STAFF REPORT

Department of Metropolitan Development Division of Planning Current Planning Section

Case Number: 2023-DV2-017 (Amended)
Address: 717 East 27th Street (approximate address)
Location: Center Township, Council District #17
Zoning: D-8
Petitioner: Lamond Jay Henderson, by Myron Cheeks
Request: Variance of Development Standards of the Consolidated Zoning and Subdivision Ordinance to provide for the construction of a three-story duplex on a 50-foot wide lot with an area of 3,250 square feet (three-story not permitted, minimum lot width of 60 feet and area of 7,200 square feet required) and a main floor area of 360 square feet per unit (660 square-foot minimum main floor area required) with a five-foot rear yard setback (20-foot rear yard setback required) having 44% open space (60% open space required).

2023-DV2-017; Site Plan

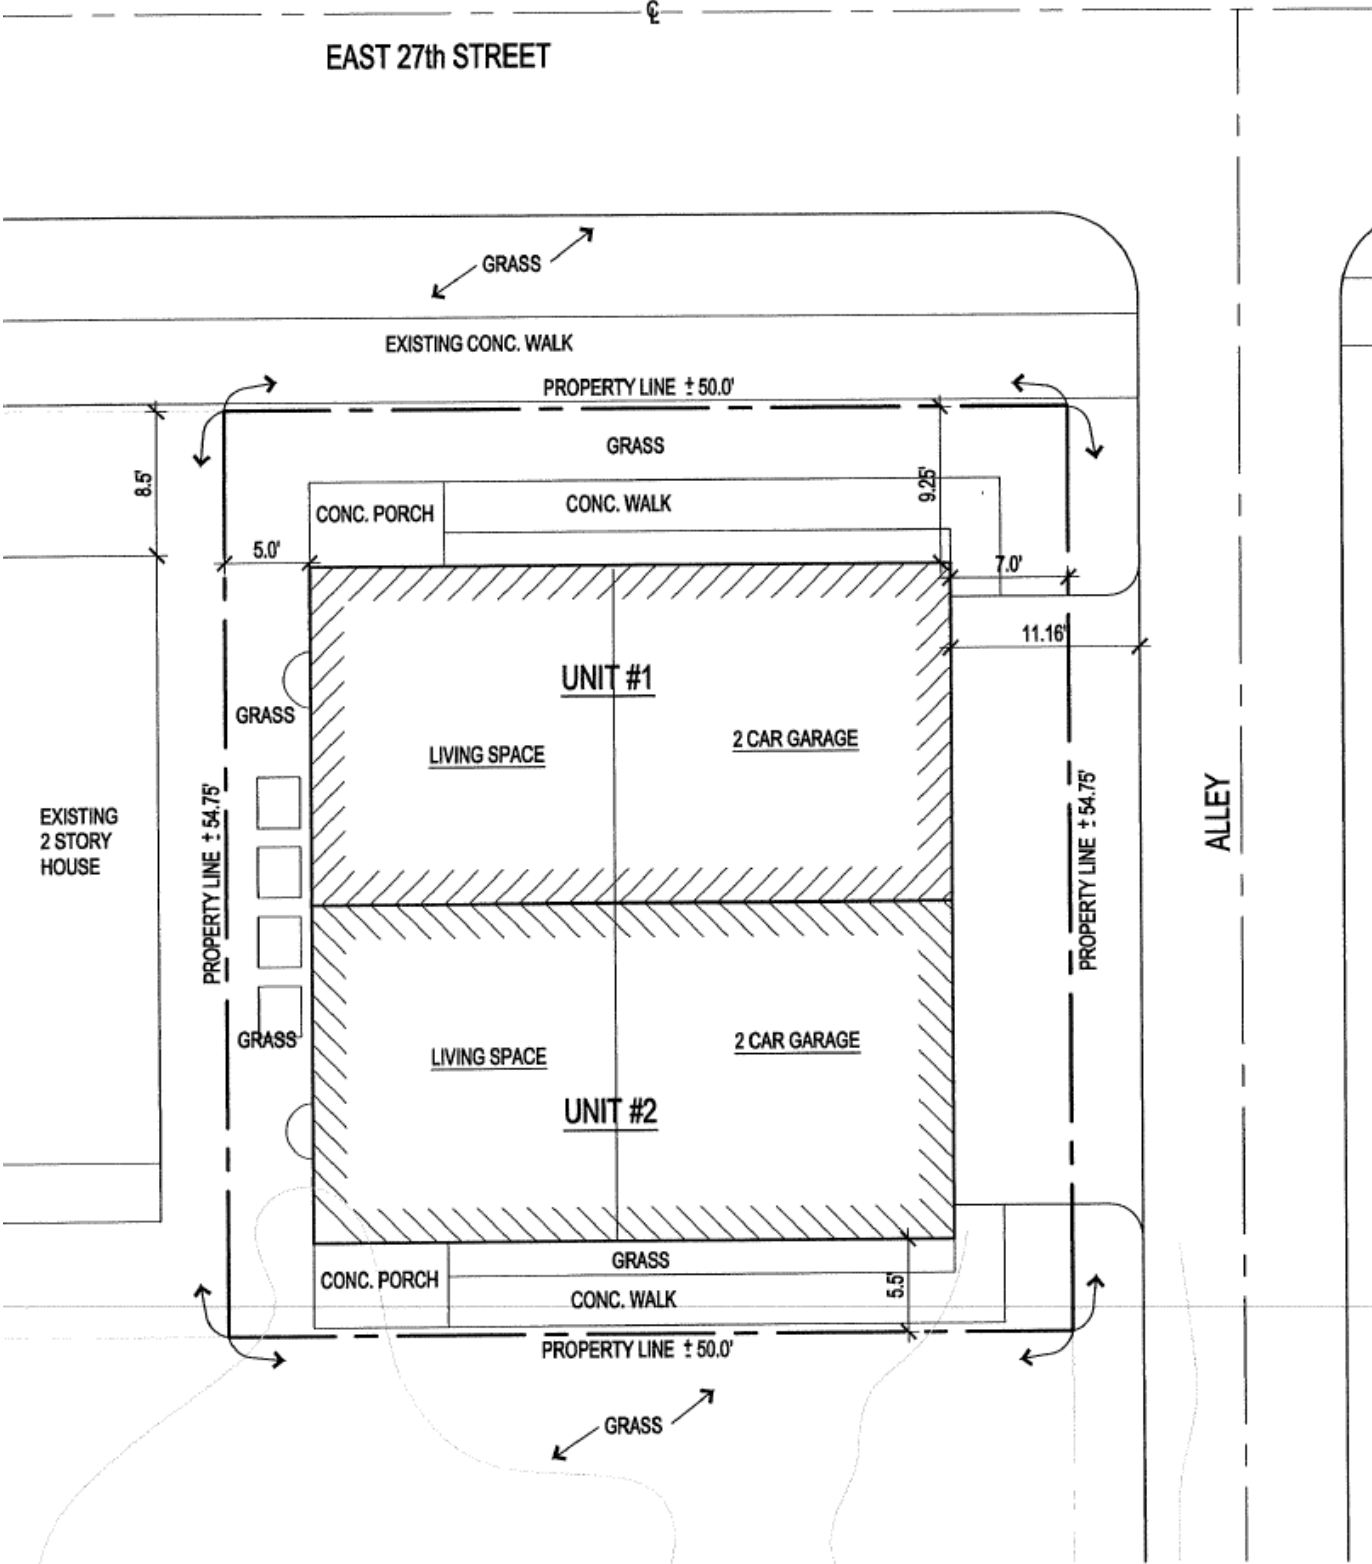
- ◇ The grant of the amended request would allow for the same three-story duplex development with changes to the lot size for 3,250 square feet with a five-foot rear yard setback and increased open space to 44%. The 5.25-foot front yard setback variance and zero-foot rear setback for the sidewalk were removed with the amended site plan.

- ◇ The building would require a 20-foot rear setback. The site plan does not note the balcony locations, but they would have the same setbacks as the covered front and rear porches noted. The east and west building elevations show the extent of the second and third floor balconies, which staff finds to be excessive for the lot size.

2023-DV2-017; Floor Plan

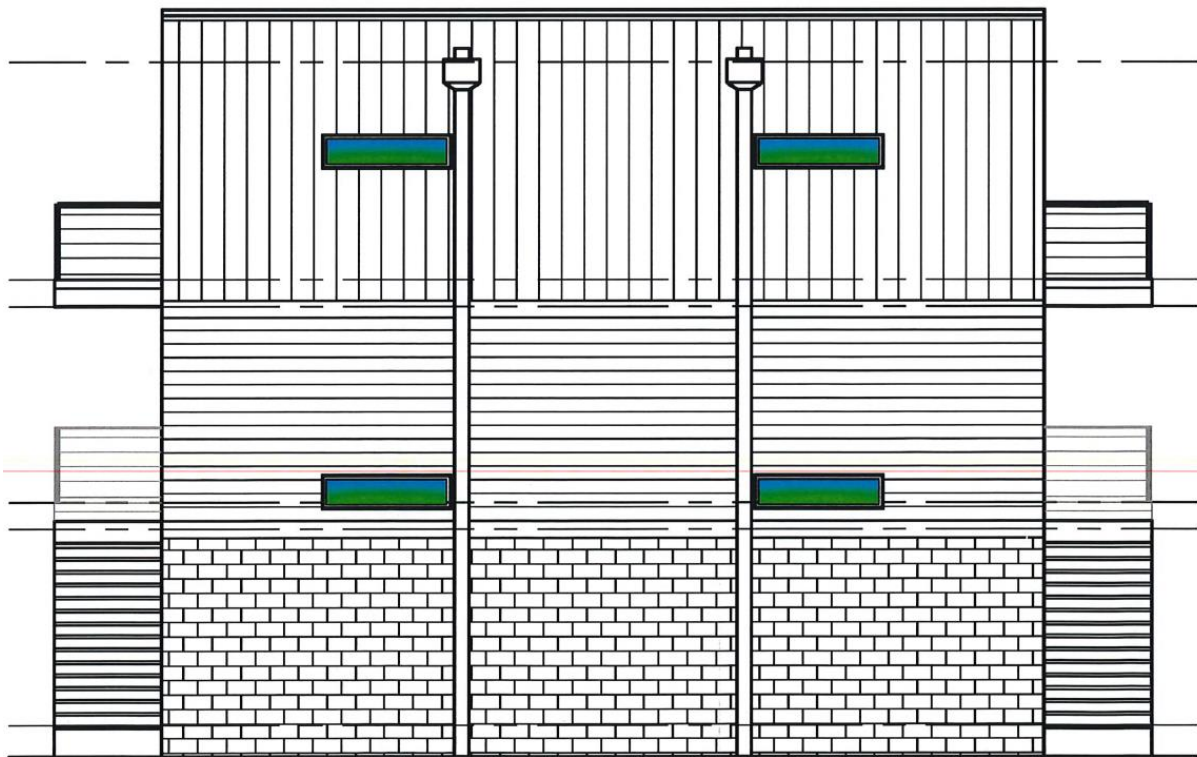
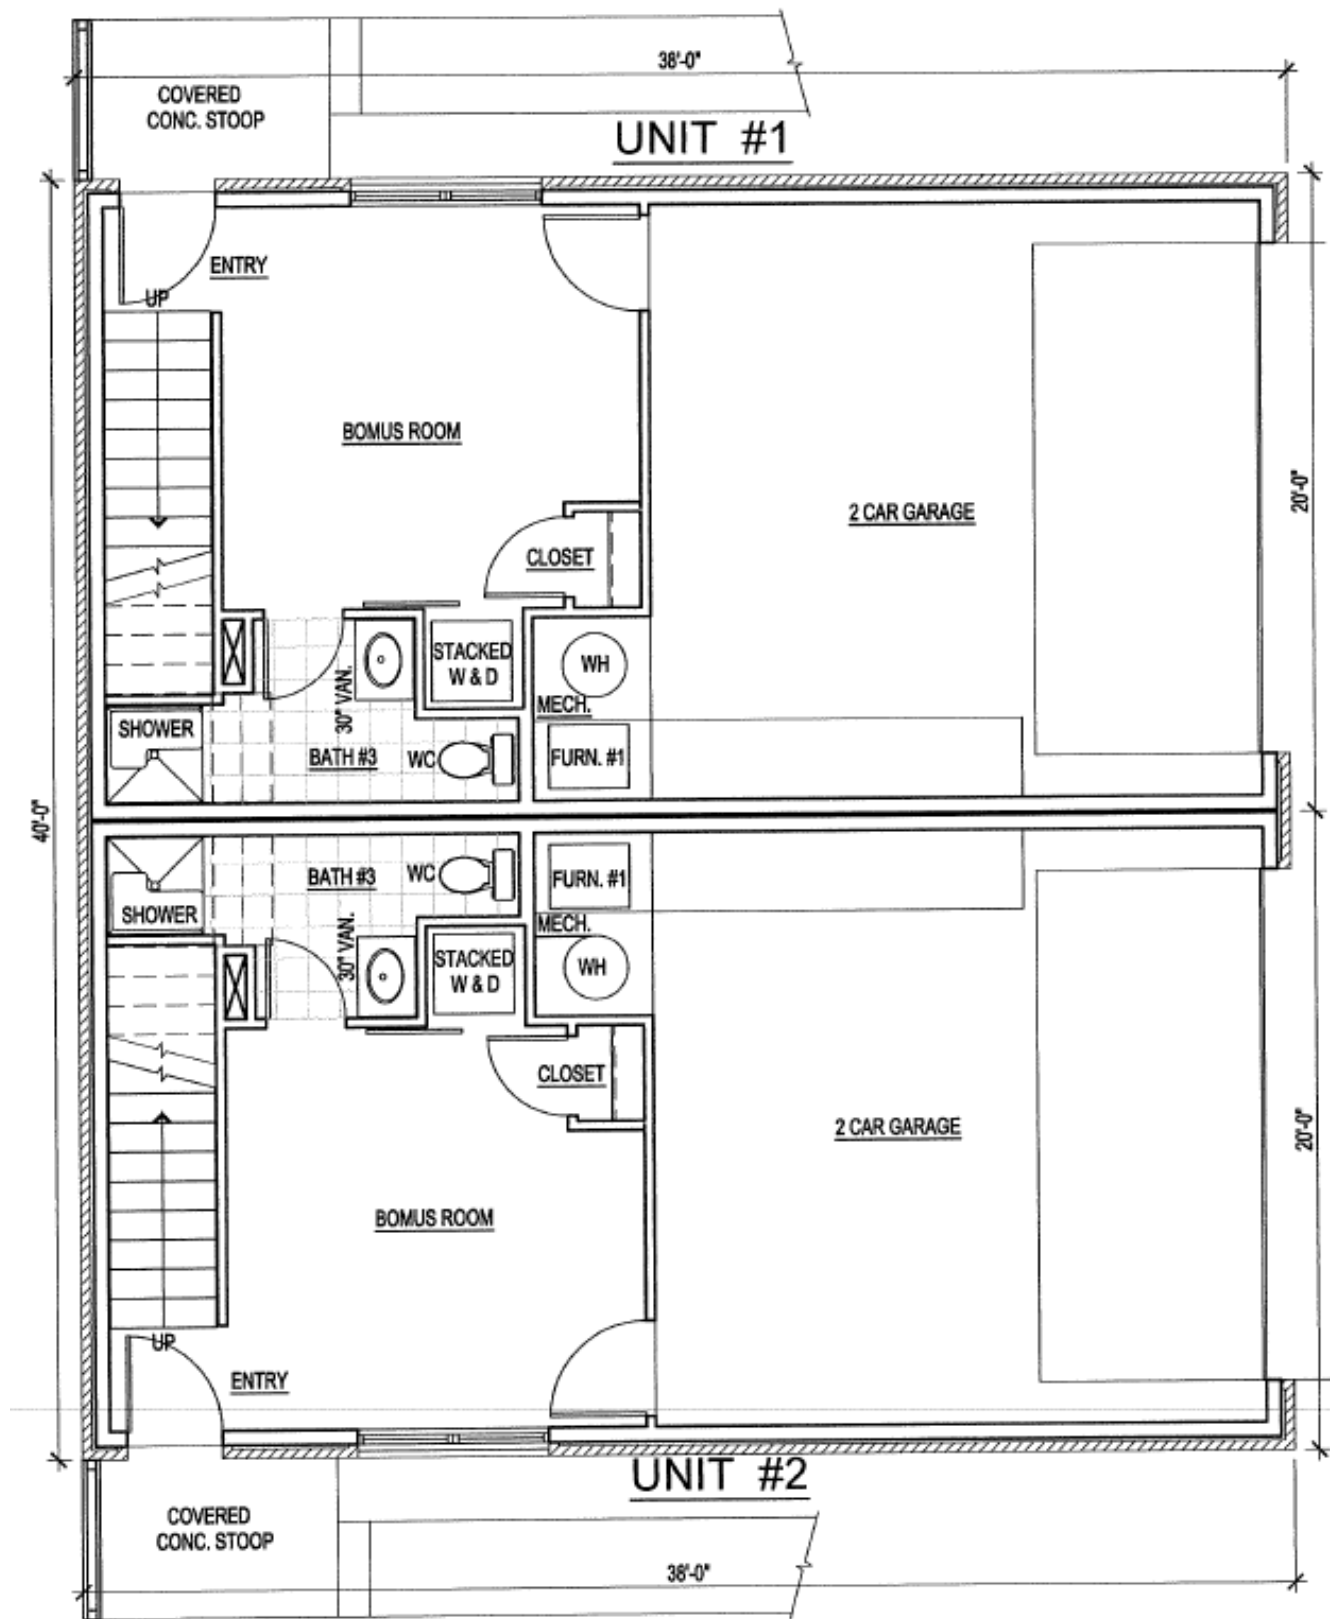
- ◇ The proposal would not be in line with the newly adopted Infill Housing Design Guidelines. Specifically with regards to the building massing since the other dwellings in the immediate area have two stories. The flat roof design would also not align with the hip and gable rooflines of the existing dwellings. The proposed fenestration for new construction should relate to the surrounding context with the proportion of glass (windows) to solid materials (wood, brick, and other materials), which would not be the case on the first-floor elevation facing the street.

- ◇ Due to the small size of the existing lot, the development of the site should be reflective of the lot limitations by not utilizing a large portion of the site for the purpose of vehicle storage and reducing the main floor area to 360 square feet. Instead, the garages could be eliminated, which would allow for the 660-square foot main floor area to be met and would further allow for a 2.5 story single-family dwelling to be proposed instead of a three-story duplex.

THIRD FLOOR PLAN

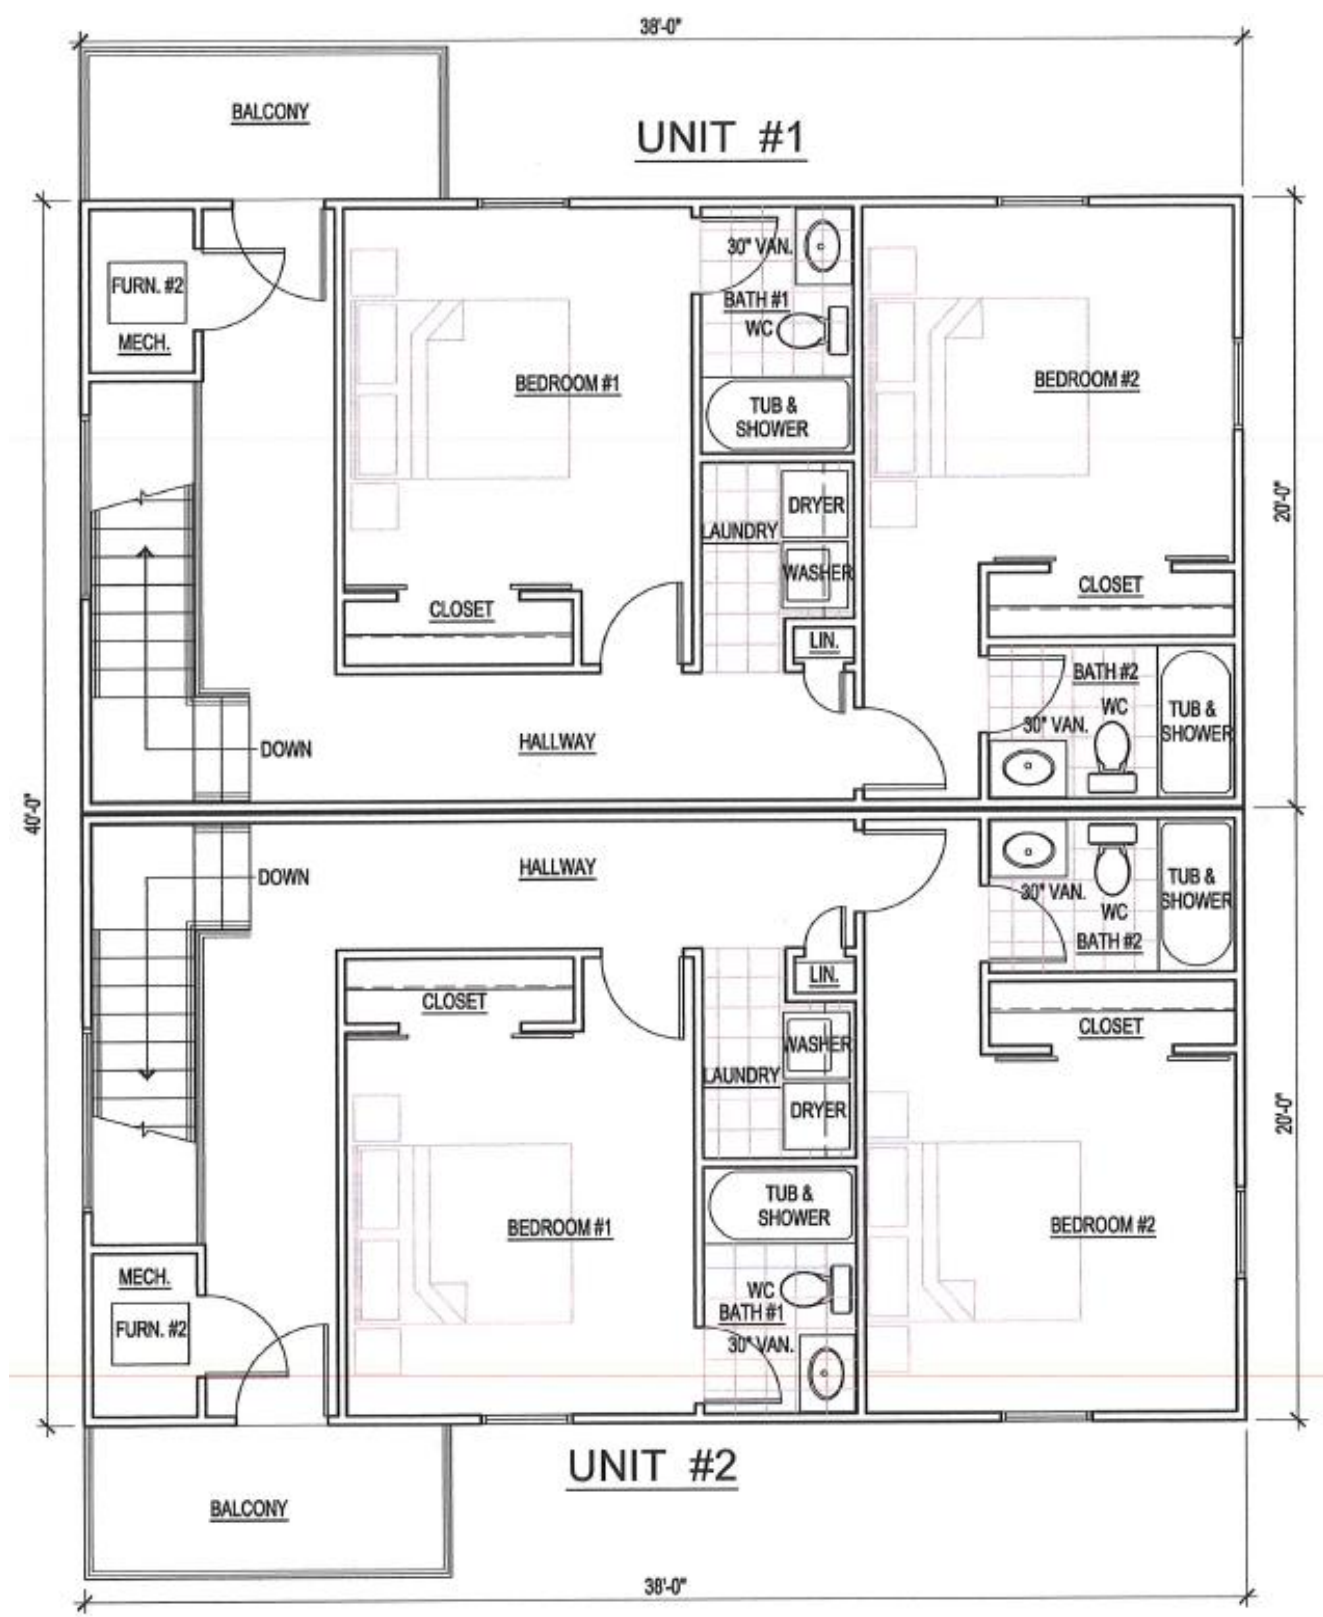
- ◇ As proposed, the third story does not meet the definition of “Story, Half”, which is “the space under a sloping roof that has a line of intersection of the roof and exterior wall face not more than 2 feet above the floor level, and where the possible floor area with headroom of 7 feet or more is no greater than 60% of the total floor area of the story directly beneath”.
